Critical Analysis of the Stream Restoration Design for Brickelmaier and Goodman Parks in Hollin Hills

Dr. John Field, President, PhD, PG
Field Geology Services (Stream restoration specialists)
Portland, Maine

I am writing to comment on Fairfax County's plan to undertake stream restoration in Goodman and Brickelmaier Parks in the Hollin Hills neighborhood. While I am a former resident of Hollin Hills, having grown up in the 1960s-70s on Brentwood Place and White Oaks Drive, my comments are based on my expertise as a fluvial geomorphologist (river geologist) and stream restoration specialist, the focus of my more than 25-year career to date. Before commenting directly on the County's restoration plans and offering an alternative approach, let me provide more background on my credentials and a short fluvial geomorphology and stream restoration primer, so my comments on the County's plans are more understandable and fully appreciated.

Figure 6. Cross section 12+09 from Stantec (2020) shows filling of existing channel and excavation of a new channel. Difference in top elevations of the banks of the two channels could lead to unraveling of the project (see text for further explanation).

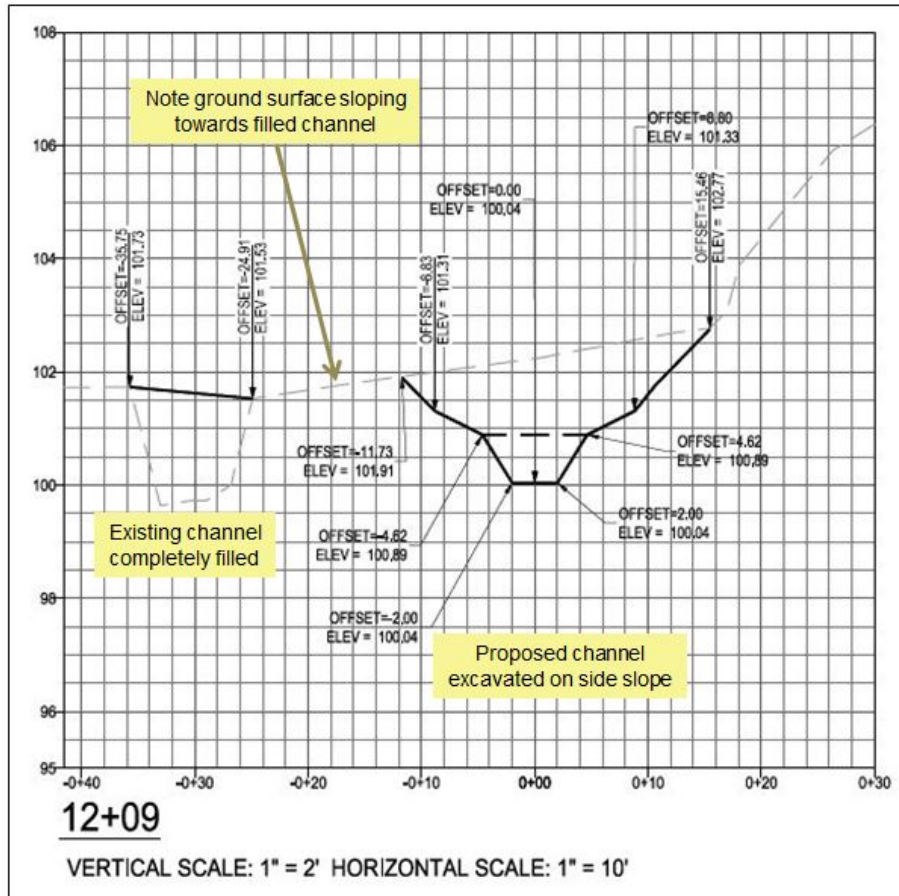
The proposed filling of existing channels and excavation of new channels creates unintended conditions that could potentially jeopardize the success of the project. Note on Figure 6 how the top elevation of the banks of the proposed channel will be higher than the existing channel to be infilled. This creates an “avulsion” risk where flow spilling out of the new channel during a flood would flow towards and become concentrated in the area of the lower infilled channel, allowing the fill to be washed away and the stream to rapidly migrate back to its old position. This rapid shift in channel position (known as an avulsion) will initiate erosion upstream as the entire stream regrades to the lower level, transporting additional sediment towards Chesapeake Bay – counter to the project’s primary objective. Therefore, minor grading issues (only 0.5 feet as displayed in Figure 6) – even if constructed as specified – could potentially lead to an unraveling of the project. While armoring the project with large rock could potentially forestall an avulsion from occurring for many decades, the risk would remain “frozen” on the landscape, so does not truly represent stream restoration that is sustainable, creates an equilibrium condition, and avoids upstream and downstream impacts.
